**AMENDMENT NO. 1 SEPTEMBER 1996
TO
IS 13432 (Part 1) : 1992 GAS LEAK DETECTOR
FOR USE WITH LOW PRESSURE LIQUEFIED
PETROLEUM GAS BURNING APPLIANCES —
SPECIFICATION**

PART 1 MECHANICAL TYPE

FIG. 1 BUBBEL LEAK INDICATOR

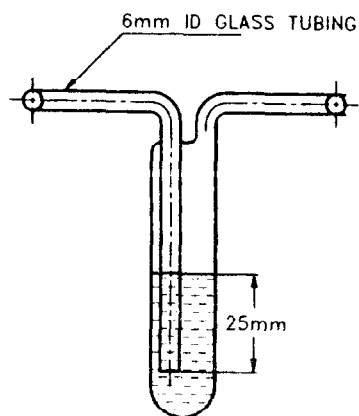
(Page 4, Annex A) — Insert the following Annex at the end:

B-1.1.1 Subject the appliance to be tested to an air supply at a pressure of 2.942 kN/m^2 (30 gf/cm^2) with the bubble leak indicator (see Fig. 1) in the air supply line. Adjust the time between two successive bubbles as 25 seconds by creating an artificial leak through needle valve or any other device. Cut off the air supply to the appliance to confine system pressure. Then observe the indication in the gas leak indicator.
